Attention: Development Assessment
Planner: Renee Ezzy
Mod2019/0029 – DA367/2010
Lot CP SP 10040 42 Victoria Parade Manly
28 February 2019

Re: SP 10040. Mod2019/029-DA0367/2010

Figure 1a: Modified DA 11am & 12 noon

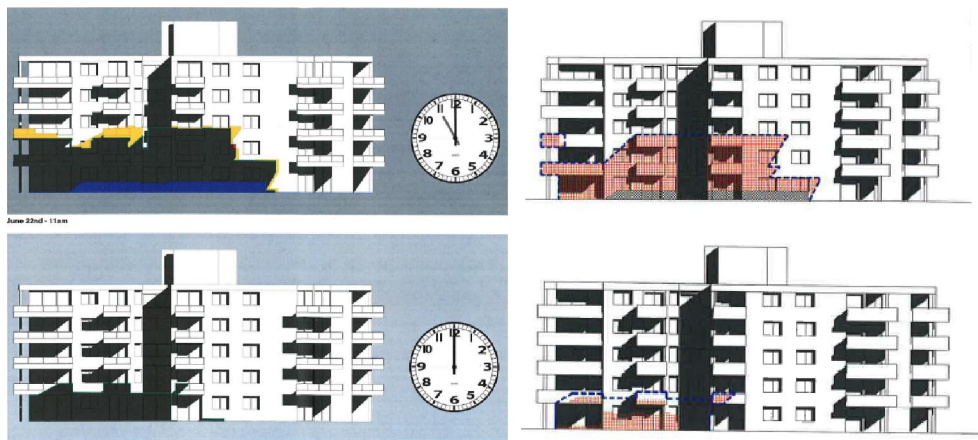
The shadow diagrams of the modified DA (Figure 1a: Modified DA 11am & 12 noon) show Unit 1 in shadow of the proposed development until midday at least. This is a substantial loss of direct sunlight compared with the original 3 storey building prior to its demolition. The shadow diagram of

the approved DA (Figure 1b: Approved DA S96-402 11am & 12 noon) indicates some direct sunlight could still be received into the internal living space of Unit 1 around midday and from 11am on in Unit 5. It is believed this is made possible by the roof “cut-out” on the western side of the roof, which was consented to in the 2014 MIAP determination to provide access to direct sunlight in both Units 1 & 5. The “cut-out” appears to be diminished in size in the modified DA (compare drawing 2424-A111 dated Dec 2018 with S96-200 dated Dec 2012), reducing any derived benefit. Unit 1 has a flat-roof room at the rear of the building extending it by 3.3 metres, which does not appear in any of the shadow diagrams. It is believed the overshadowing of the reduced “cut-out” will adversely affect its sun access also.

On the basis of these shadow diagrams, there is significant deterioration in sun access for both Units 1 & 5, resulting from the proposed modified DA.

Furthermore, there are significant differences between the shadow diagrams of the approved DA (S96-402) and its representation on the modified DA shadow diagram. On the basis of the set of diagrams provided, I request the modified DA be rejected on the grounds of further reduction of direct sunlight into Units 1 & 5.
